Subject: Request for Amendment to License R-93, Docket No. 50-185 Revising
Organizational Structure in Support of Plum Brook Reactor Facility
Decommissioning

AMENDMENT TO LICENSE NO. R-93

PROPOSED AMENDED FACILITY LICENSE

License No. R-93
Amendment No. 7

FIGURE 1

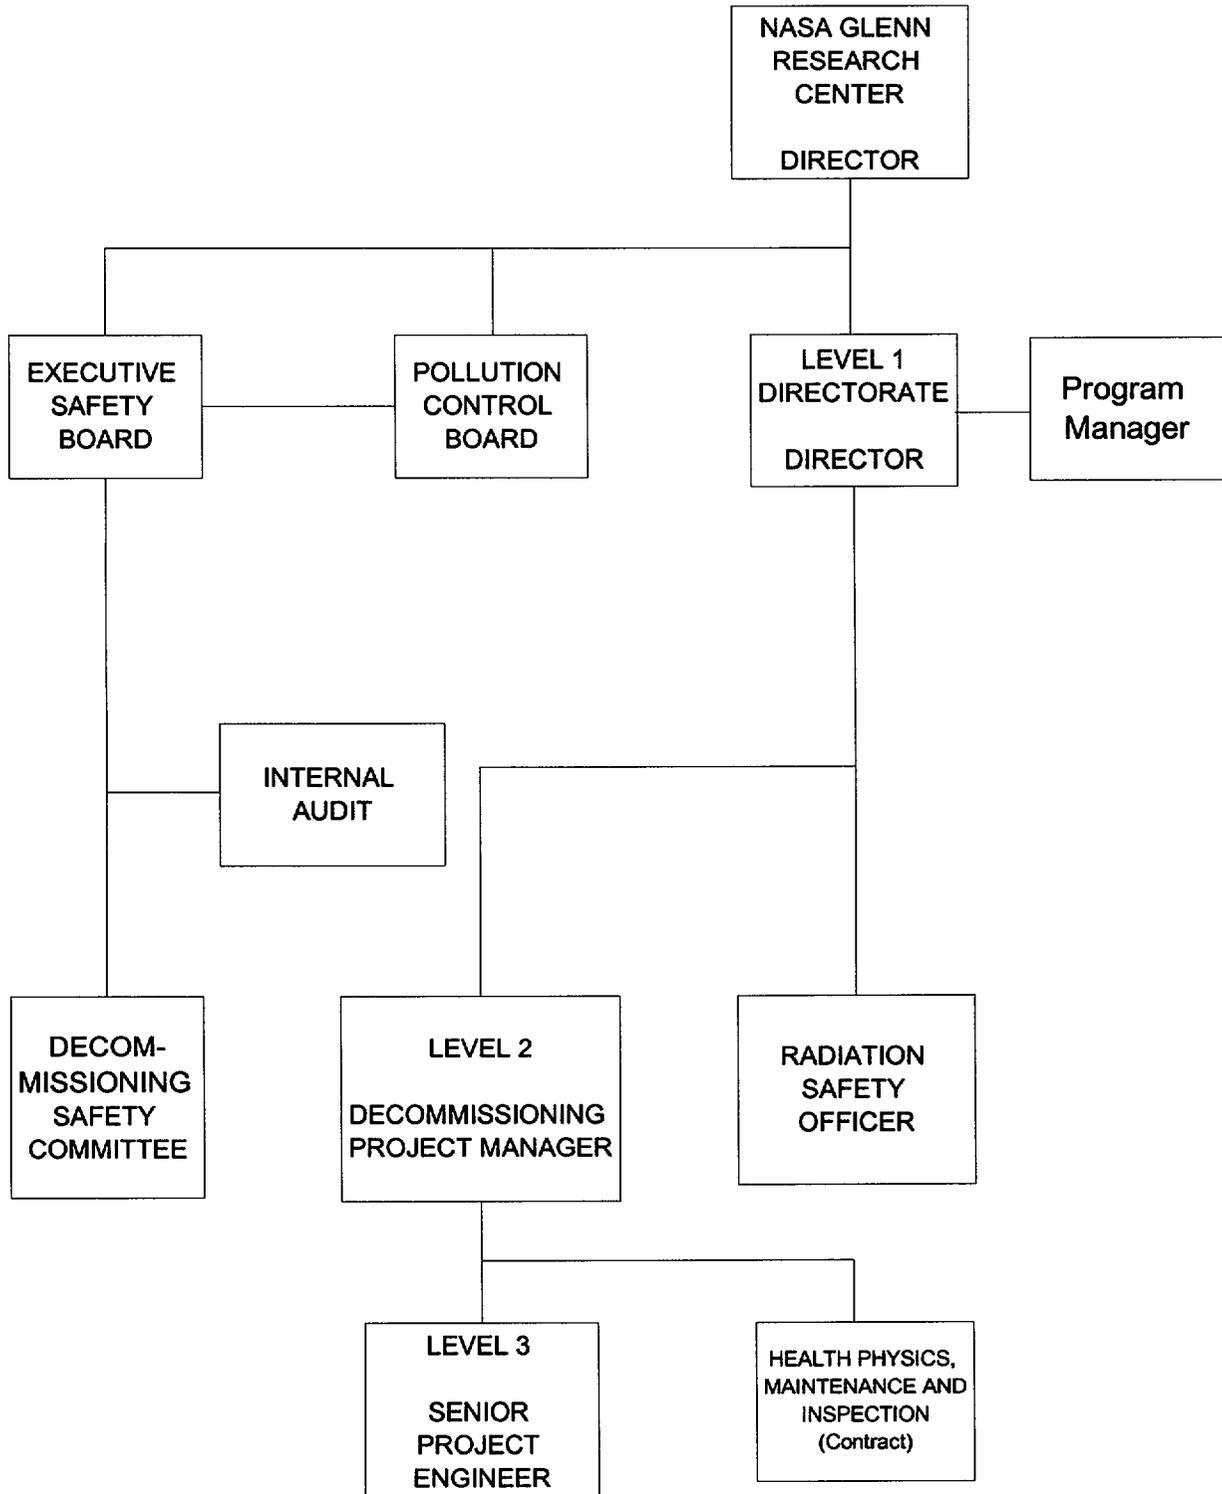
The MUR is owned by the National Aeronautics and Space Administration (NASA), which is responsible for maintaining the PBRF as required by these Technical Specifications. NASA shall provide whatever resources are required to maintain the PBRF in a condition that poses no hazard to the general public or to the environment. Figure 1 is the Generic Organization Chart.

Level 1 – Glenn Research Center directorate is responsible for assuring compliance with the reactor facility license and providing regulatory reports and correspondence. The Director shall have overall responsibility for the license and the subsequent decommissioning and license termination.

Level 2 - The Decommissioning Project Manager shall be responsible for overall on-site operation in safe storage and through license termination. This includes administering programs that assure the proper operation, control, and safeguards are maintained for PBRF. The PBRF Decommissioning Project Manager or his designee shall approve, prior to implementation, each phase of decommissioning or license termination that affect nuclear safety.

Level 3 - The Decommissioning Senior Project Engineer shall be responsible for day-to-day supervision of PBRF activities.
